GROUP 54

CHASSIS ELECTRICAL

OUTLINE OF CHANGES

<Petrol-powered vehicles>

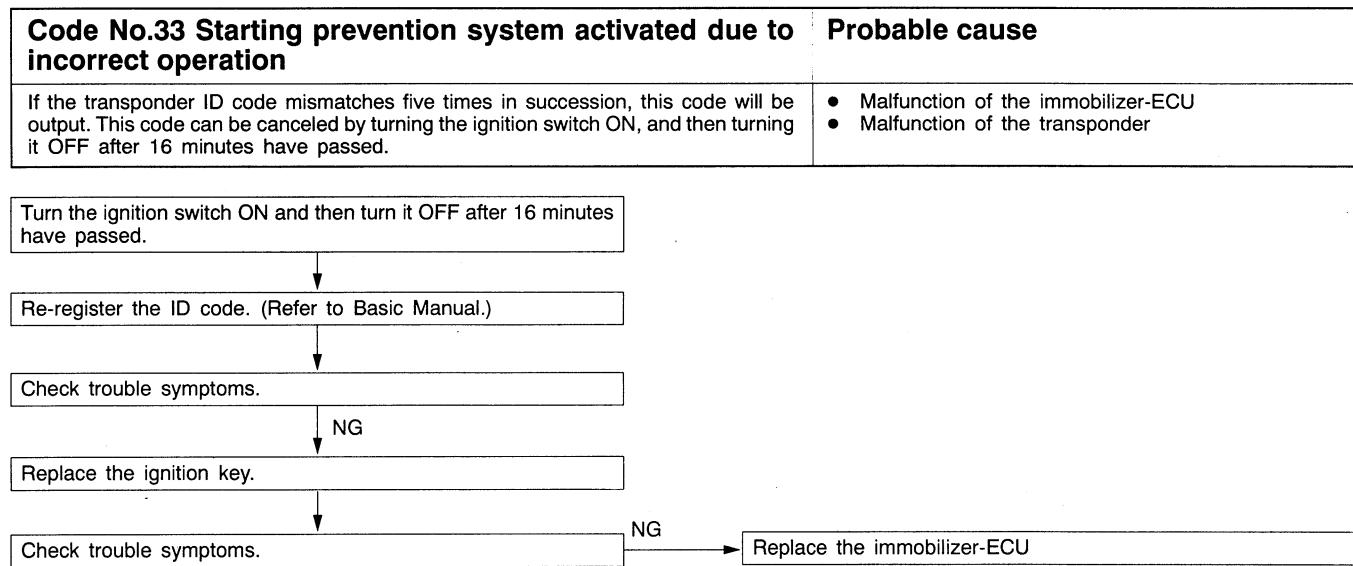
- The removal service point for the headlamp (L.H.) has been added to correspond to the addition of the diesel-powered vehicle.
Applicable models: 1900D <Vehicles with air conditioner>
- The troubleshooting for the immobilizer system has been added to correspond to the addition of the diesel-powered vehicle.
Applicable models: 1900D
- The following service procedures have been added to correspond to the addition of the 4-door sedan.
 1. Removal and installation of the rear combination lamp and rear lid lamp
 2. Removal and installation of the high-mounted stop lamp
 3. Removal and installation of the rear speakers
- The troubleshooting section has been changed to correspond to the addition of the diagnosis code No.33 to the immobilizer system.
Applicable models: Petrol-powered vehicles

INSPECTION CHART FOR DIAGNOSIS CODES

Diagnosis code No.	Inspection items	Reference page
11*	Transponder communication system	-
12*	ID code are not the same or are not registered	-
21	Communication system between immobilizer-ECU and engine-ECU	-
31	EEPROM abnormality inside immobilizer-ECU	-
33*	Starting prevention system activated due to incorrect operation	54-2

Code No.21 Communication system between immobilizer-ECU and fuel injection pump

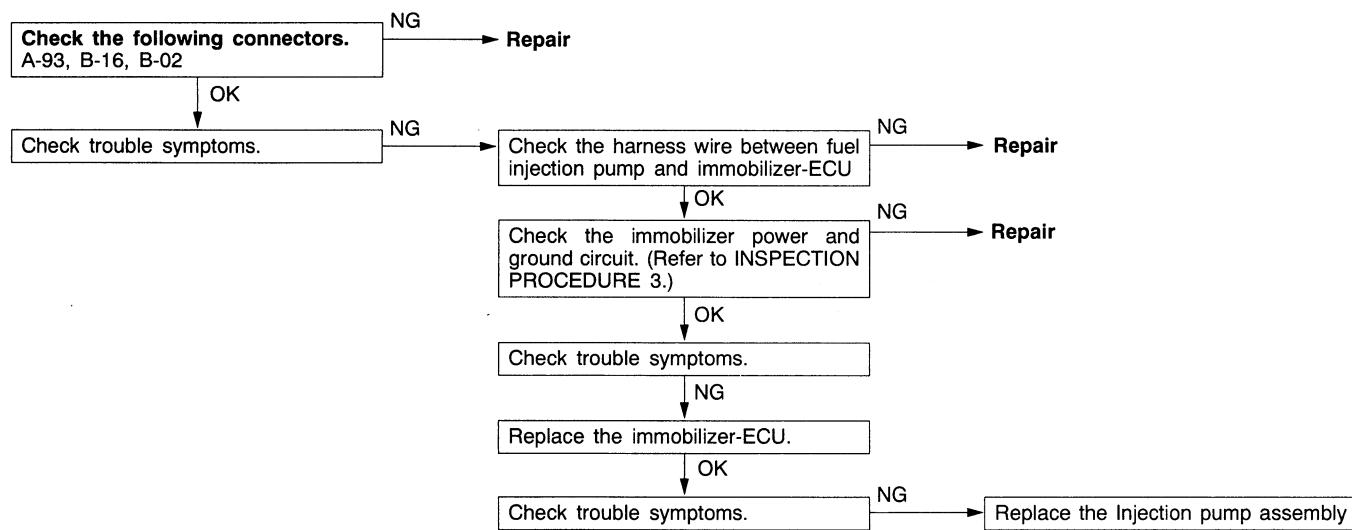
After the ignition switch is turned to the ON position, the confirmation code is not received from the fuel injection pump within the allowable time, or an abnormal code is received.

- Malfunction of harness or connector
- Malfunction of the fuel injection pump
- Malfunction of the immobilizer-ECU
